United States Patent and Trademark Office

APPLICATION NO.	FILING DATE	FIRST NAMED INVENTOR	ATTORNEY DOCKET NO.	CONFIRMATION NO.
09/869,215	08/11/2003	Boaz Porat	83143	1259
7590 05/01/2006			EXAMINER	
Welsh & Katz			DEPPE, BETSY LEE	
22nd Floor 120 South Riverside Plaza			ART UNIT	PAPER NUMBER
Chicago, IL 60606-3913			2611

DETAILED ACTION

FIG 1

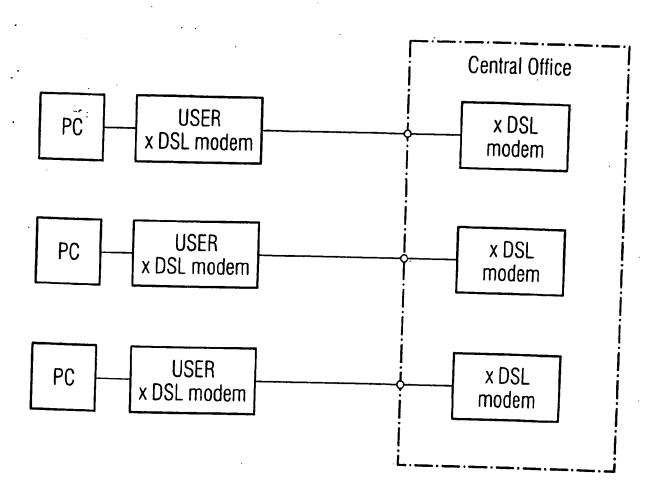
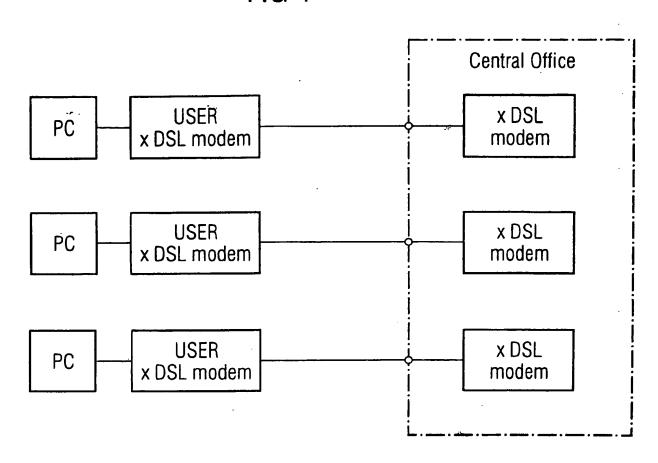
- 3. Drawings were received on November 14, 2005 and February 21, 2006. The drawings filed November 14, 2005 are acceptable. The drawings filed February 21, 2006 are not acceptable because of typographical errors and the pages are not labeled as "Replacement Sheet" in the header.
- 4. The drawings are objected to because the elements in Figure 6 should be labeled so that one viewing the drawings may understand the subject matter of the claimed invention without referring to the detailed description.

Corrected drawing sheets in compliance with 37 CFR 1.121(d) are required in reply to the Office action to avoid abandonment of the application. Any amended replacement drawing sheet should include all of the figures appearing on the immediate prior version of the sheet, even if only one figure is being amended. The figure or figure number of an amended drawing should not be labeled as "amended." If a drawing figure is to be canceled, the appropriate figure must be removed from the replacement sheet, and where necessary, the remaining figures must be renumbered and appropriate changes made to the brief description of the several views of the drawings for consistency. Additional replacement sheets may be necessary to show the renumbering of the remaining figures. Each drawing sheet submitted after the filing date of an application must be labeled in the top margin as either "Replacement Sheet" or "New Sheet" pursuant to 37 CFR 1.121(d). If the changes are not accepted by the examiner, the applicant will be notified and informed of any required corrective action in the next Office action. The objection to the drawings will not be held in abeyance.
